Access Compliance Report

Public Rights-of-Way

(Curb Ramps)

Intersection ID: 11779	Main Street: KEMPTON_PL	Cross Street: PRUITT_ST	Location: SE
ADA ID: 61FC7FE66ABD	Ramp Type: Perp	Initial Pass/Fail: Fail	Overall Compliance: No
Severity Score: 21.25			
Codes/Mitigation Info/Possible Solution		Field Measurements/Component Compliance

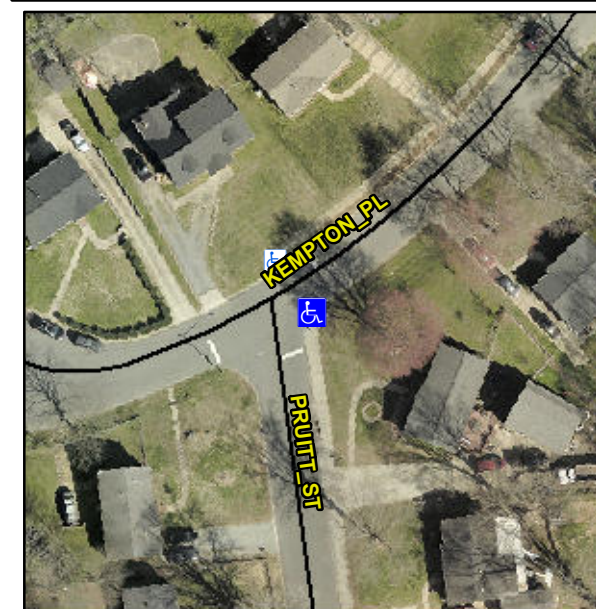
Not Found, R304.5.1, R304.5.3

Compliance	Description	Data	Compliance	Description	Data
N/A	Ramp Length (in)	66.5	Yes	Ramp Slope (%)	6.2
No	Ramp Width (in)	47.5	No	Ramp XSlope (%)	5.2
N/A	Flare Type LT	N/A	N/A	Flare Type RT	N/A
N/A	Flare Slope LT (%)	N/A	N/A	Flare Slope RT (%)	N/A
N/A	Flare Traversable LT?	N/A	N/A	Flare Traversable RT?	N/A
N/A	Landing Length (in)	N/A	N/A	DWS Provided?	N/A
N/A	Landing Width (in)	N/A	N/A	DWS Contrast?	N/A
N/A	Landing Slope (%)	N/A	N/A	DWS Length (in)	N/A
N/A	Landing X Slope (%)	N/A	N/A	DWS Full Width?	N/A
N/A	Landing Curb? (Y/N)	N/A	N/A	DWS Offset (in)	N/A
N/A	Shared Landing?	N/A			
N/A	Gutter Ponding?	N/A	N/A	Gutter Slope (%)	N/A
N/A	Gutter Lip Ht (in)	N/A	N/A	Gutter X Slope (%)	N/A
N/A	Painted X Walk1?	No	N/A	Painted X Walk2?	N/A
	X Walk 1 Direction	To N		X Walk 2 Direction	N/A
N/A	X Walk 1 Width (in)	N/A	N/A	X Walk 2 Width (in)	N/A
	X Walk 1 Slope (%)	0.6		X Walk 2 Slope (%)	N/A
	X Walk 1 X Slope (%)	3.2		X Walk 2 X Slope (%)	N/A

Remove & Replace Entire Ramp.
